2361 Springsid Dr.

DISAPPROVED

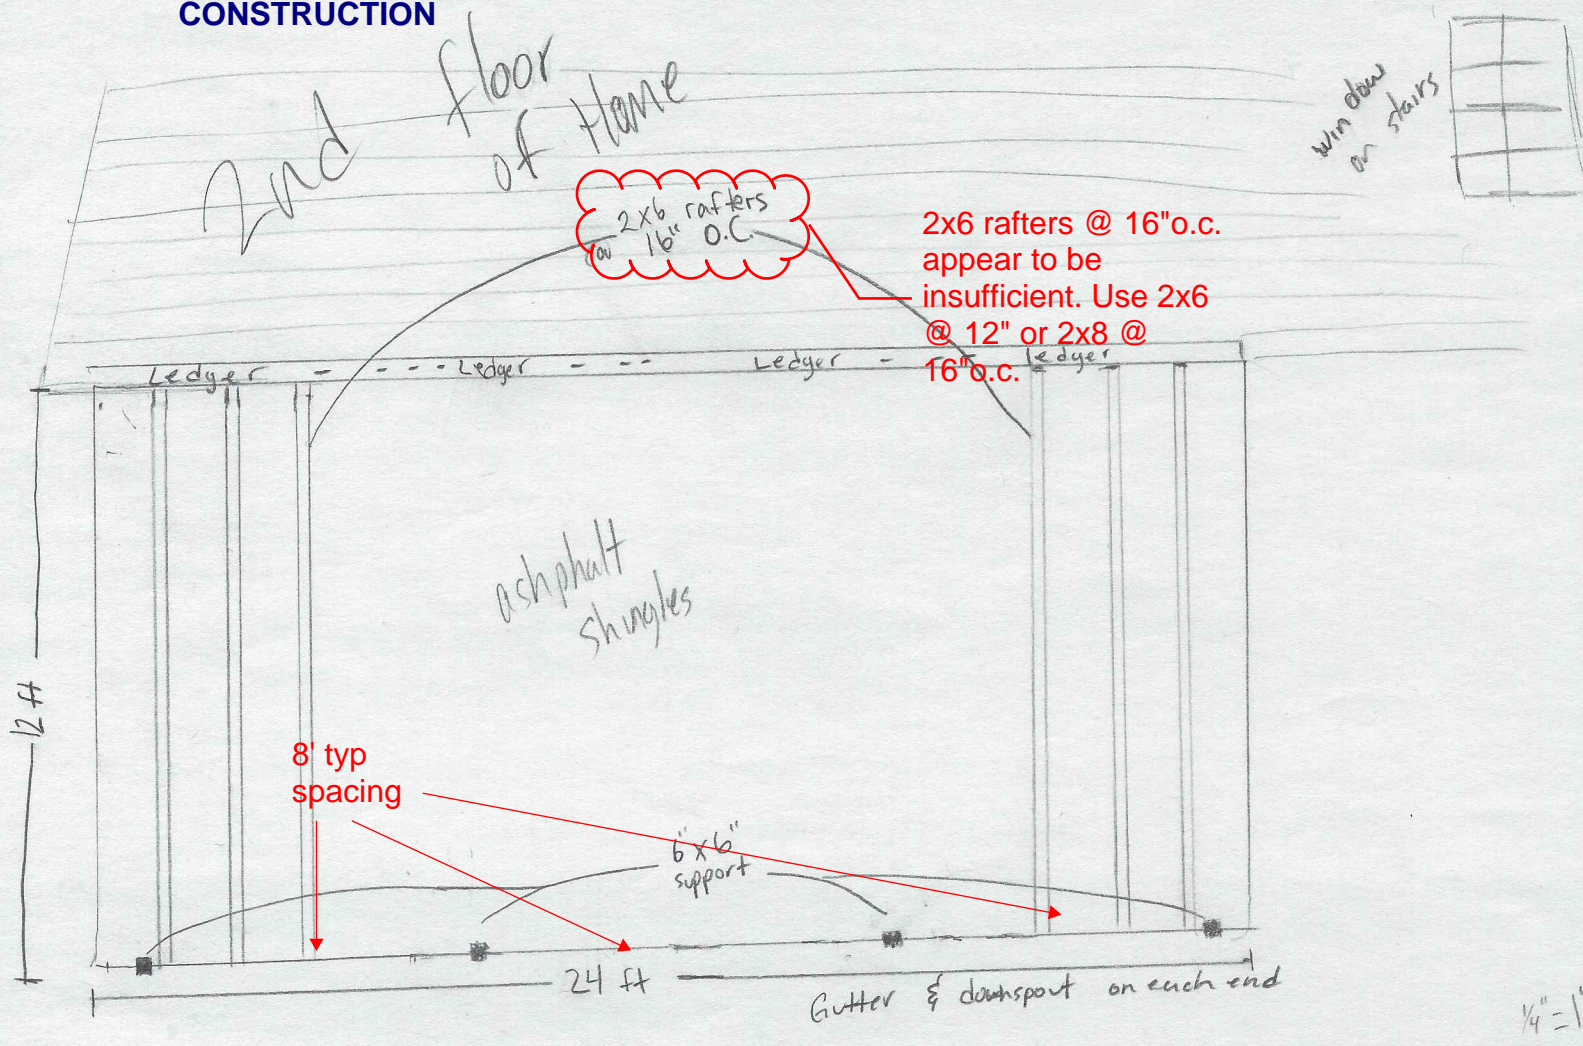
Provide clearer detail for connection to house.

Specify roofing materials proposed.

Clarify if rafters go past beam, or end flush. Double 2x6 beam inadequate. Triple 2x6 or double 2x8 will work, however. Revise.

2x6 rafters @ 16" o.c. appear to be insufficient. Use 2x6 @ 12" or 2x8 @ 16" o.c.
